Stockton Sand Quarry Groundwater Management Plan

IA147700_001f | F

19 December 2019

Stockton Sand Quarry- Groundwater Monitoring and Modelling Plan Review

FIGURE1
Boral Stockton Sand Quarry
Existing Groundwater
Monitoring Network

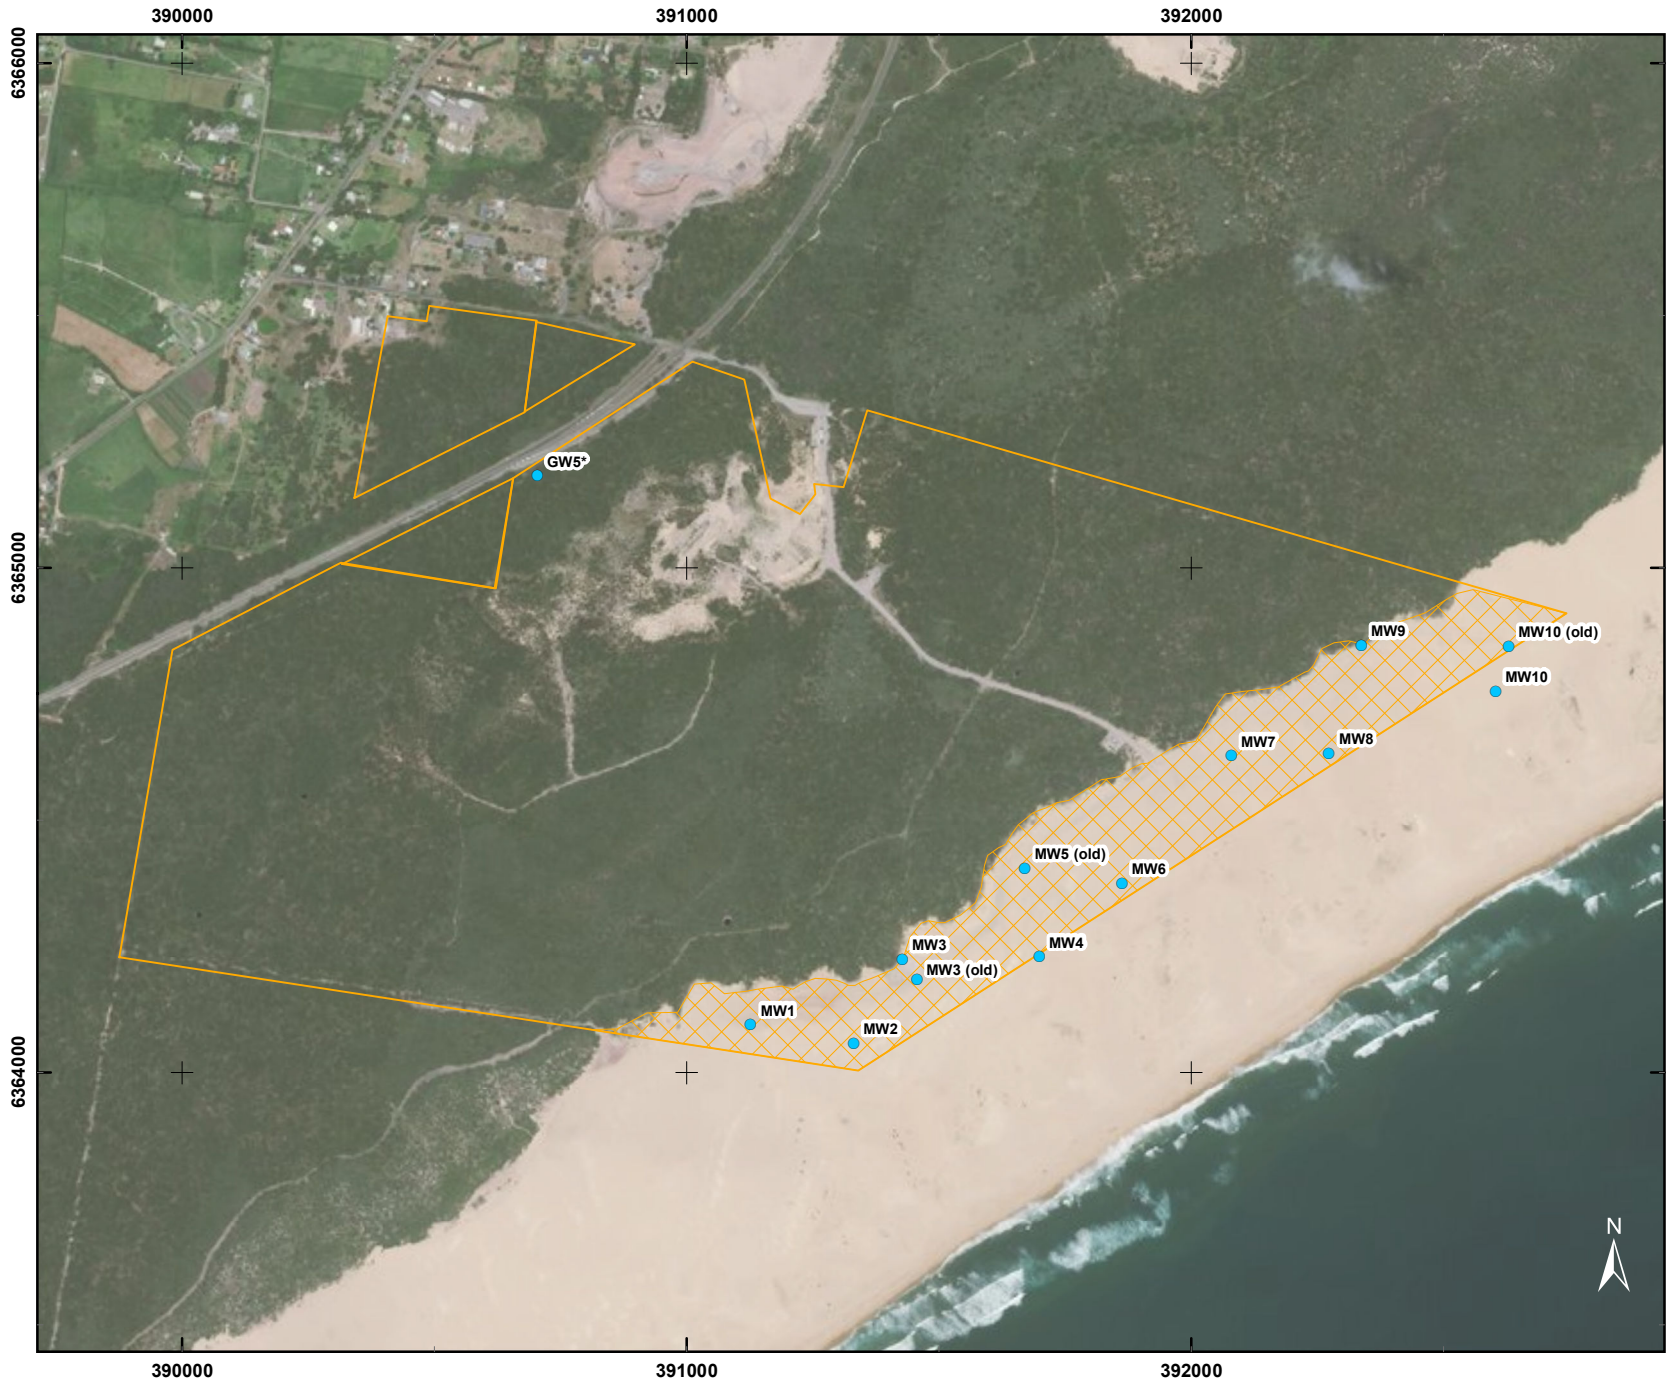
- Clearly identify all of the 12 listed monitoring bores on the location figure. It is noted that the current figure only shows 8 new monitoring bores. The older 'GW series' bores are not shown.

FIGURE 2
Boral Stockton Sand Quarry
Historic Groundwater
Monitoring Network

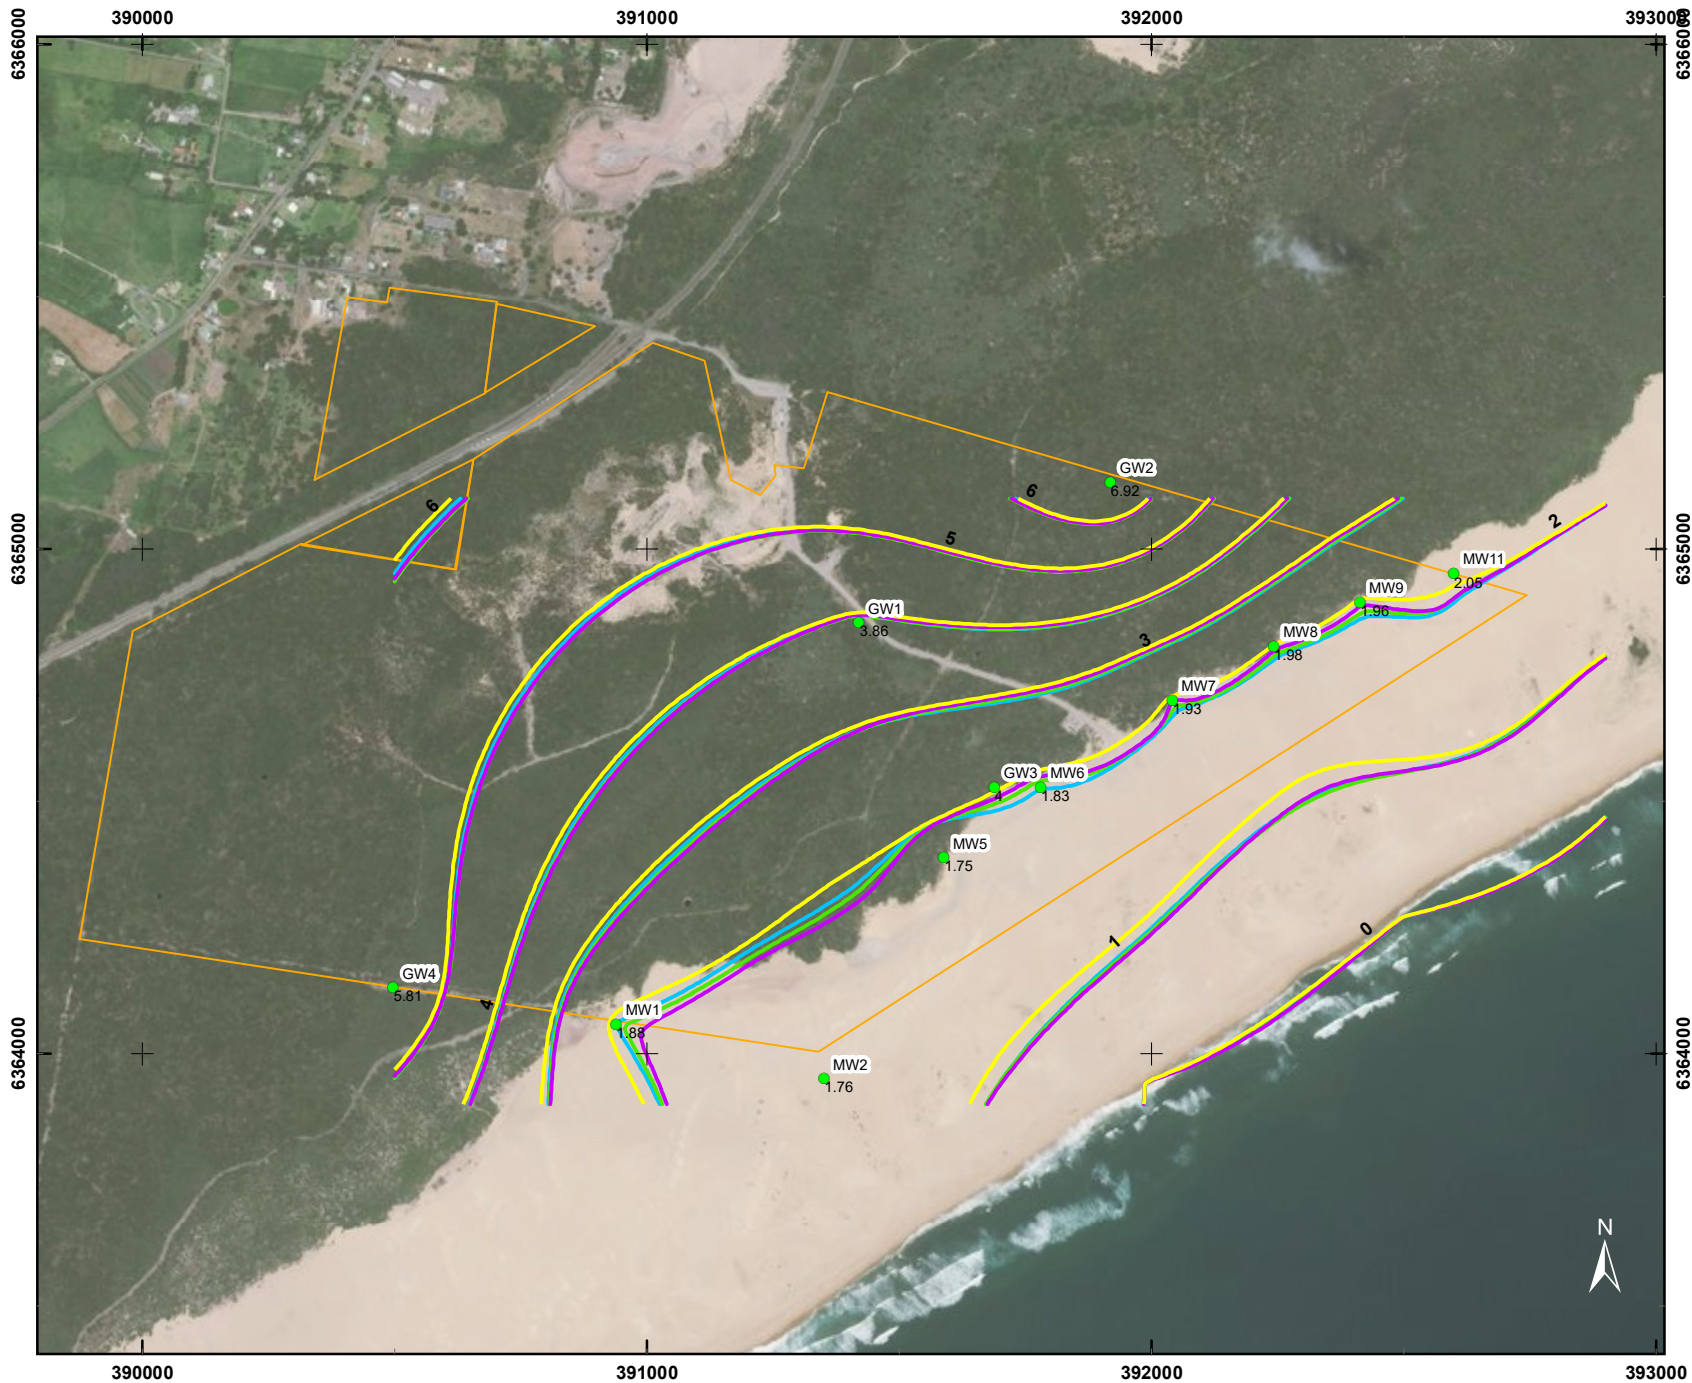
- A figure showing the location of the defunct historical monitoring bores.
- Groundwater level, height (m AHD) contour plans or flow nets drawn from the recorded groundwater levels over a series of months or quarters.
